TOLEDO - LUCAS COUNTY PLAN COMMISSIONS

REF: SUP-12006-22

SUBJECT: Amendment to Special Use Permit, originally granted by Ord. 90-19 and Ord. 293-21, for Glass City Metropark Campground at 1821 Front Street

SITE PLAN

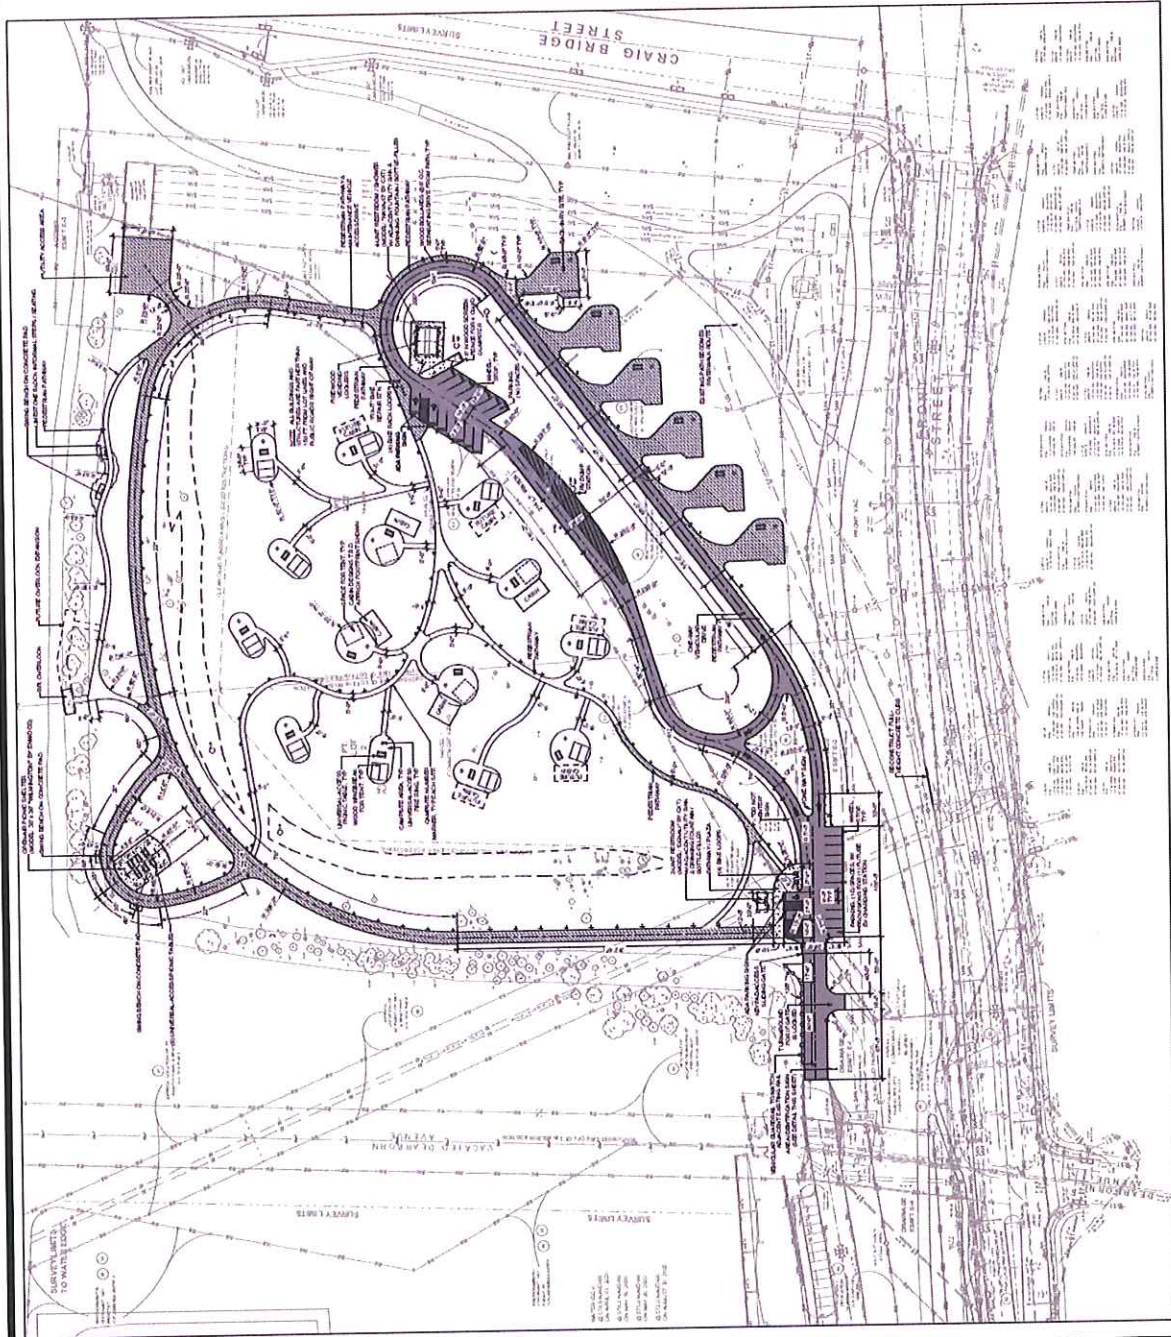
Pursuant to TMC§1107.0600 - Off-Street Parking Schedule "D", Community Recreation facilities have a wide variety of parking demand characteristics, making it difficult to specify a single off-street parking standard. Therefore, Schedule "D" parking allows the minimum off-street parking requirements to be established via a parking study, which was provided by the applicant. The applicant determined that the appropriate number of parking spaces is 1.4 per rentable campsite, as the RV sites may be occupied by an additional vehicle towed by the RV. The site plan depicts twenty (20) campsites for people to rent, and the applicant provided twenty-six (26) parking spaces. The Director approves of the alternative parking plan.

A portion of the total number of required off-street parking spaces must be specifically designated, located, and reserved for use by persons with physical disabilities. According to the table in TMC§1107.1701 – *Number of Required Parking Spaces for Persons with Disabilities*, the applicant is required to provide at least one (1) van accessible space with an eight-foot (8') drive aisle for persons with physical disabilities. The site plan depicts four (4) van accessible spaces and meets the requirement.

Bicycle parking is required pursuant to Off-Street Parking Schedule "A" (TMC§1107.0300). A minimum of one (1) bicycle space shall be provided per ten (10) automobile parking spaces. The submitted site plan depicts four (4) bicycle parking spaces and meets the bicycle parking requirement.

SHEET TITLE
OVERALL
PLANTING PLAN

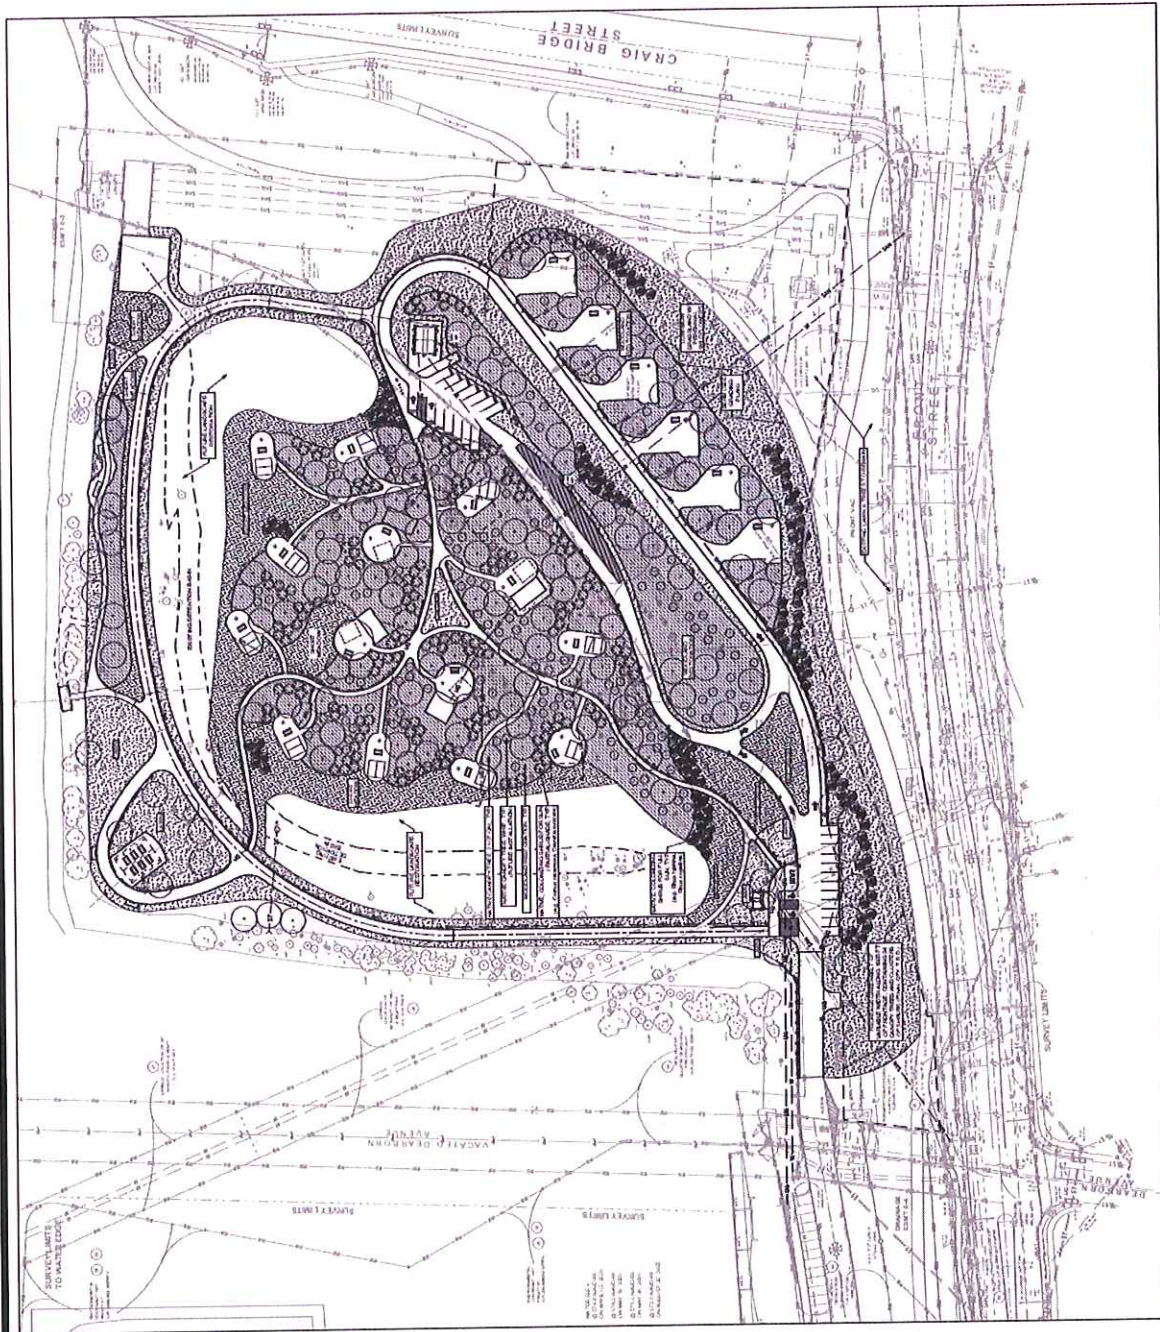
The submitted landscape plan depicts various plantings and botanical features throughout the site. A frontage greenbelt of containing thirty-four (34) canopy trees and clusters of shrubs was provided. The campgrounds are well landscaped with native canopy trees, several varieties of prairie mixes, as well as areas to be dedicated to landscape restoration. A landscape berm will buffer the campgrounds from Front Street and Craig Bridge Street. Staff approves of the landscape plan.

ELEVATIONS

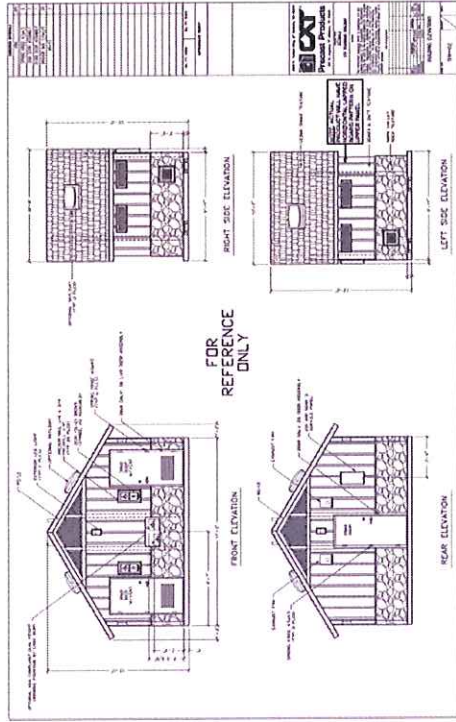
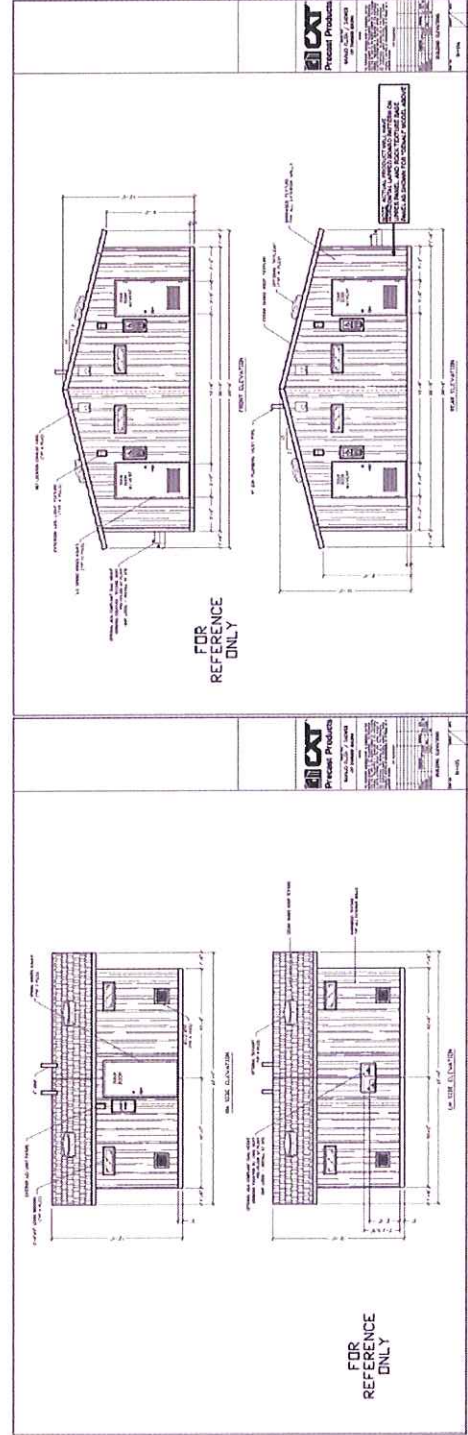
The site plan depicts buildings for restrooms and showers, with an open-air picnic shelter at a lookout point. Elevations depict buildings of concrete cladding. Colors shall be subtle, neutral, and earth tone. The design of the cabins has yet to be determined, and will need approval from the Marina District Architectural Review Committee prior to construction.
